Application for Waiver from Construction Standards for Public Water Systems

Water System Name: Portland Water Bureau

Project or Facility: SW Alder Phase 2

Construction standard requested to be waived: OAR 333-061-0050 (9)(b) water sewer separation

Plan Sheet

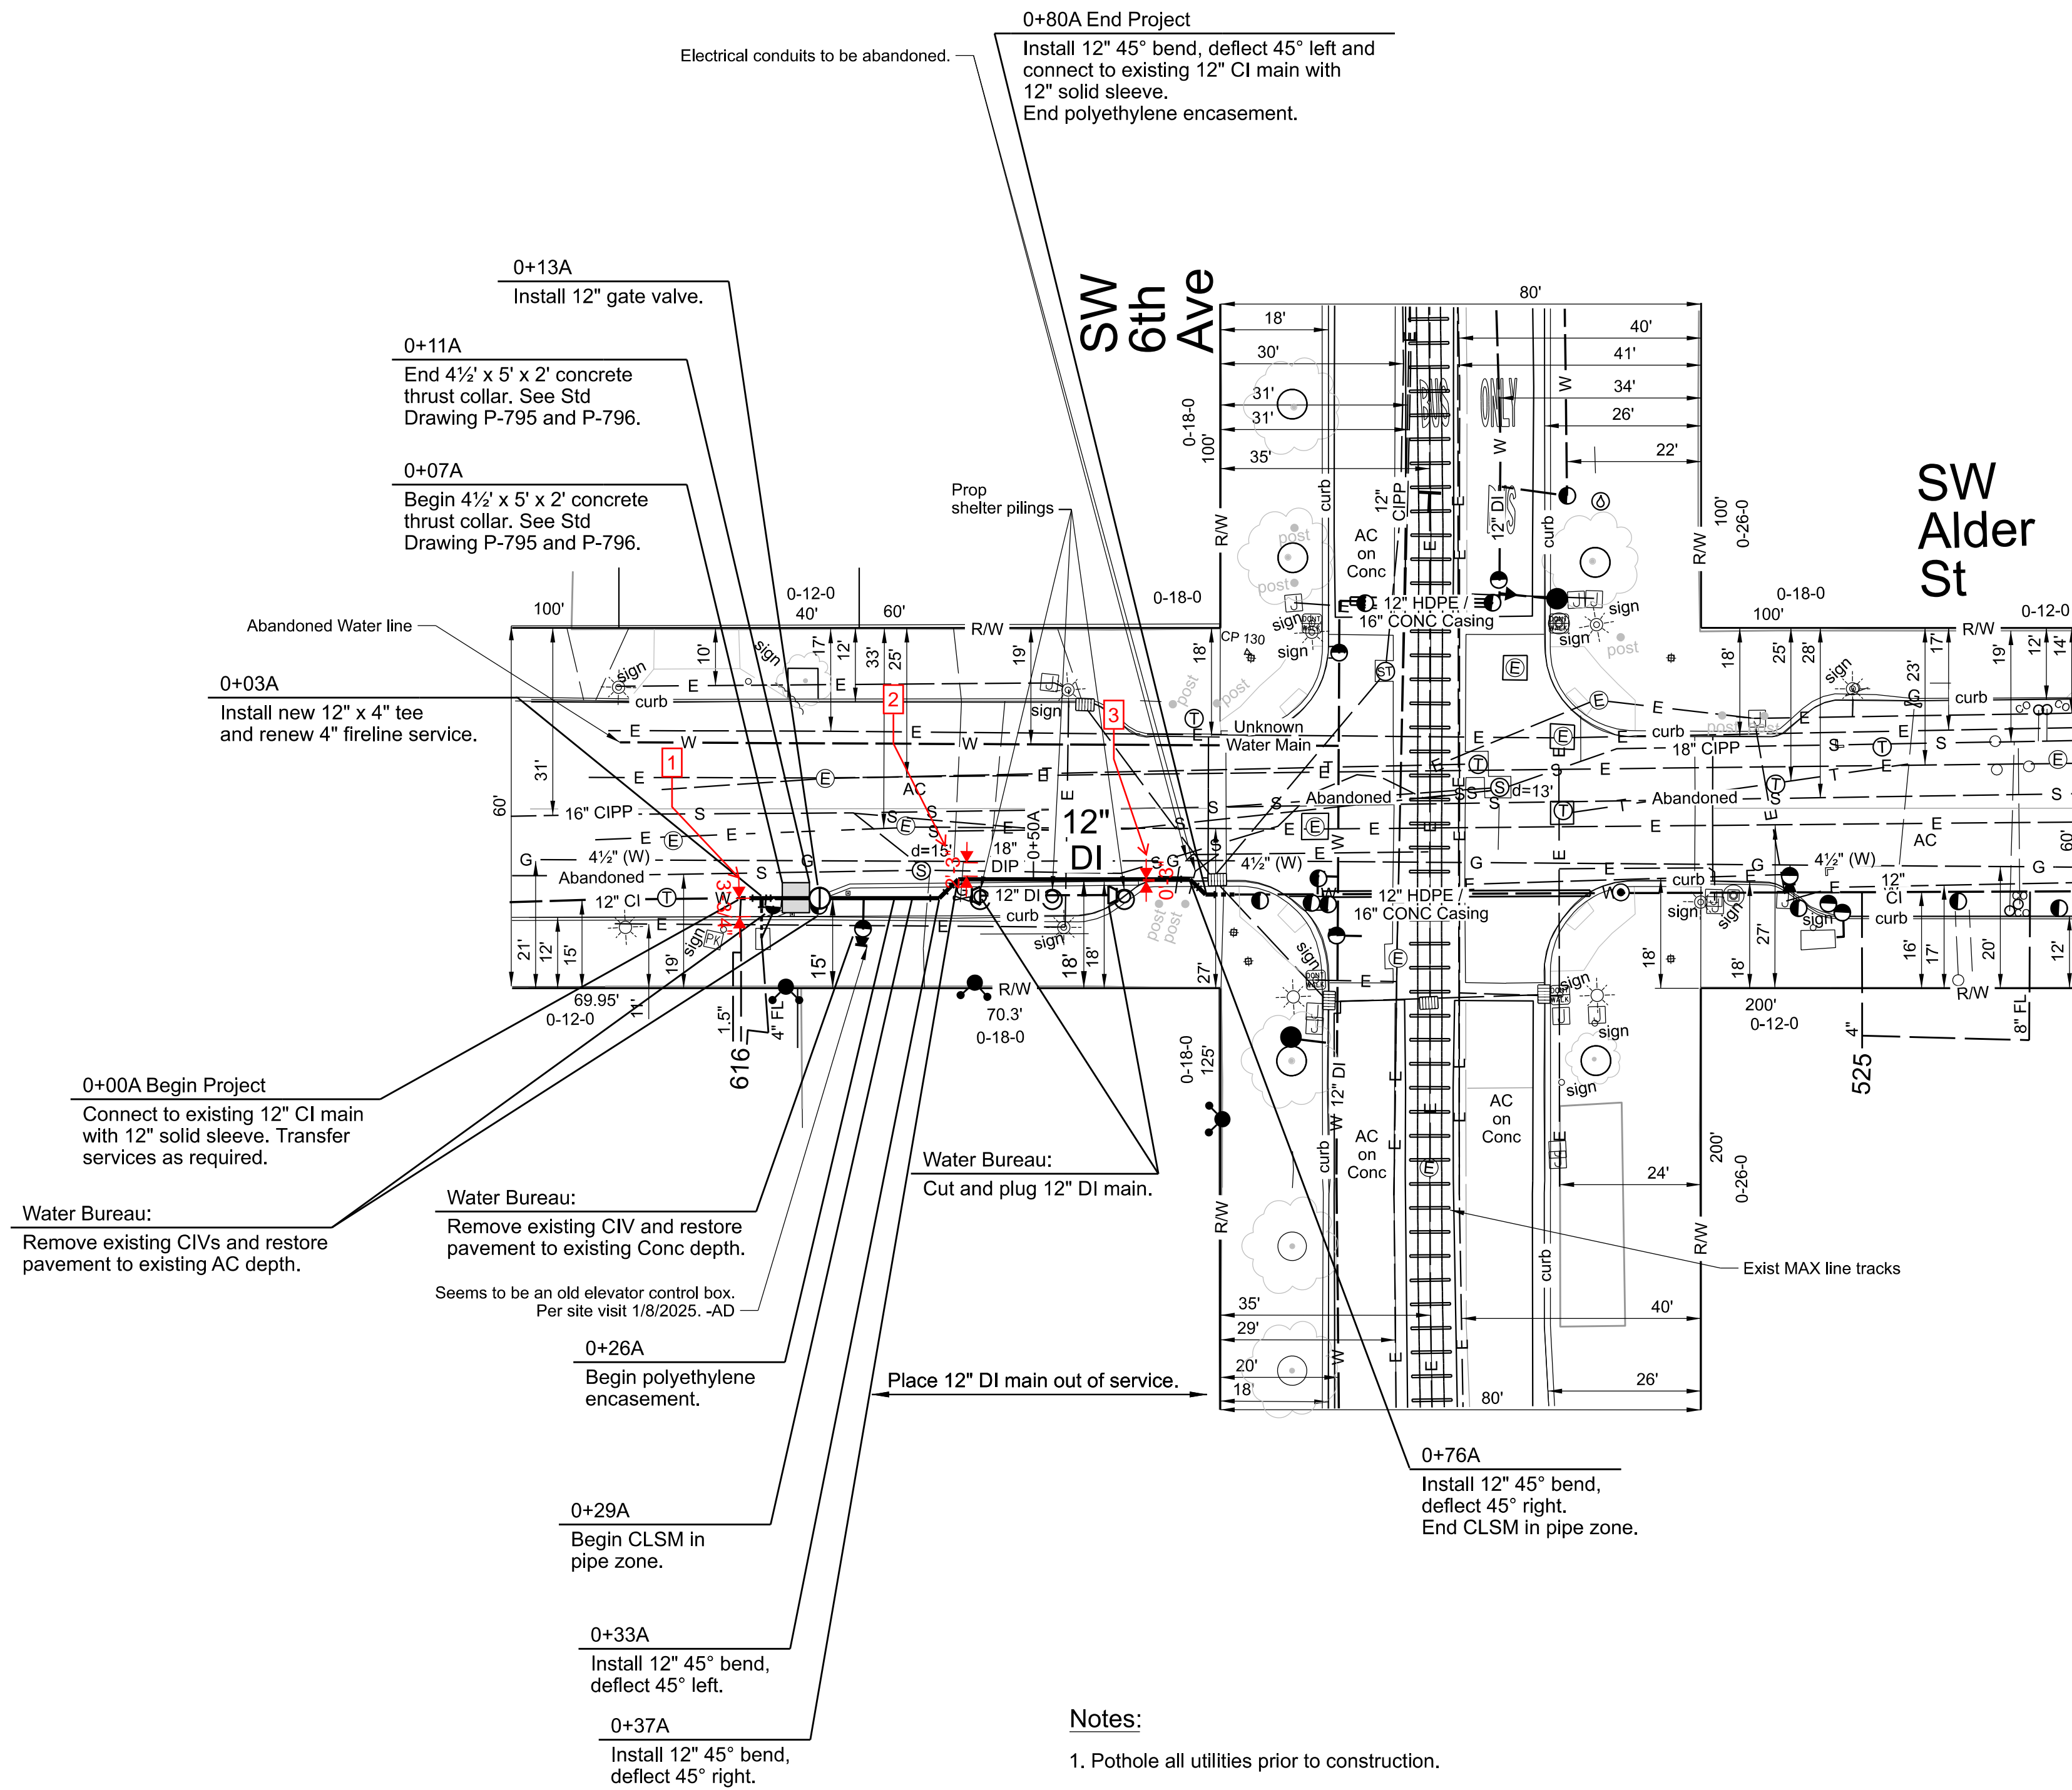
Describe situation that conflicts with the standard. Note this is a revised submittal from a construction waiver 00657-wv-2025-526 previously approved in March 2025. Water pipe which currently only has <1' of parallel horizontal separation from an existing sewer pipe will be relocated to make room for improvements to the sewer pipe and to increase separation between the two. After realignment, there will be 2' of parallel horizontal separation from 0+37A to 0+76A and 3.5' of parallel horizontal separation from 0+20B to 0+94B, creating Zone 2 conflicts in both locations. Describe why meeting the standard is highly burdensome or impractical. Many utility conflicts exist in this street. Multiple alignment options were explored, including the previous submittal, which were not feasible and had greater degrees of conflict.

Describe proposed alternate measure that provide adequate protection to public health and safety. The proposed water pipe will be encased in CLSM from 0+29A to 0+76A and from 0+03B to 1+03B.

☒ Plan Review Coordinator's notes: CLSM is an adequate alternative measure in this scenario.
